ALERT SERVICE BULLETIN

429-21-55

MODEL AFFECTED: 429

SUBJECT: MAIN ROTOR PITCH CHANGE LINK UPPER RETENTION BOLT 20-114C5P47AD, ONE-TIME INSPECTION OF.

Figure 1 – Example of Main Rotor Pitch Link Upper Retention Bolt 20-114C5P47AD with the “ π ” (pi) symbol visible.

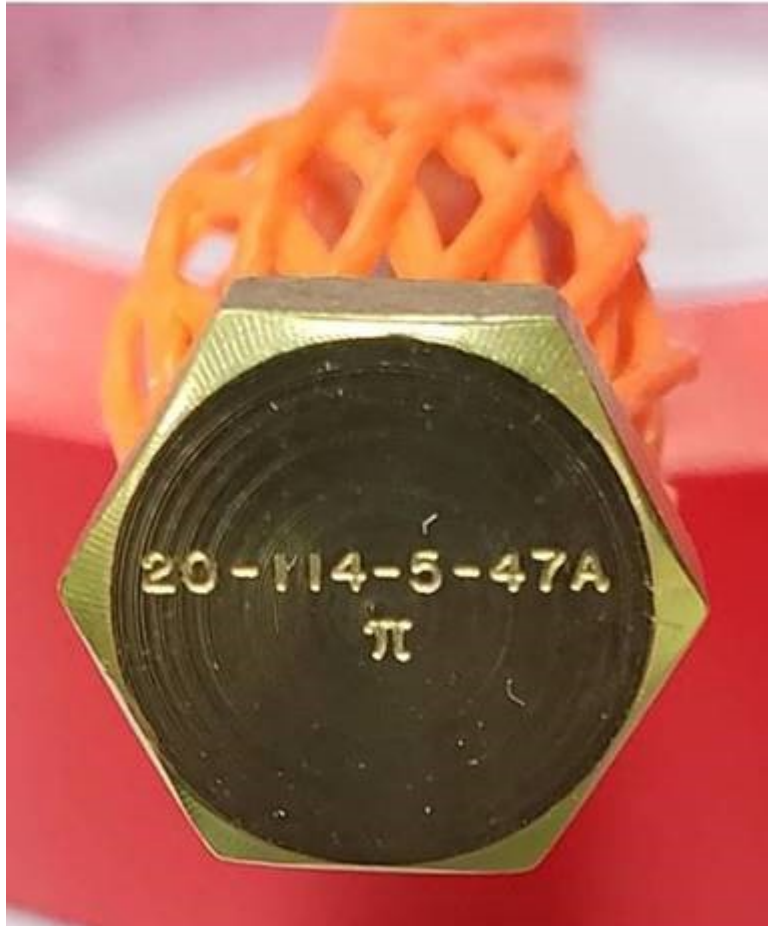
1. Prepare the helicopter for maintenance.
2. Remove the corrosion preventative compound from the four (4) main rotor pitch change link upper retention bolt heads and inspect to identify the bolts:
 - a. If the bolt head has a “**π**” (pi) symbol (Figure 1), remove (DMC-429-A-62-30-00-00A-520A-A) and proceed to step 3.
 - b. If the bolt head does not have the “**π**” (pi) symbol, proceed to step 8.

6. Discard the discrepant bolt(s) and replace with (a) serviceable 20-114C5P47AD bolt(s).
7. If you find a discrepant bolt, inform Bell Product Support Engineering by sending an e-mail at productsupport@bellflight.com. Make sure that the following information is included:
 - a. Helicopter serial number in the subject line.
 - b. ASB Number in the subject line: ASB 429-21-55
 - c. Photo of the discrepant bolt head.
8. Make an entry in the helicopter logbook and historical service records indicating compliance with this Alert Service Bulletin.
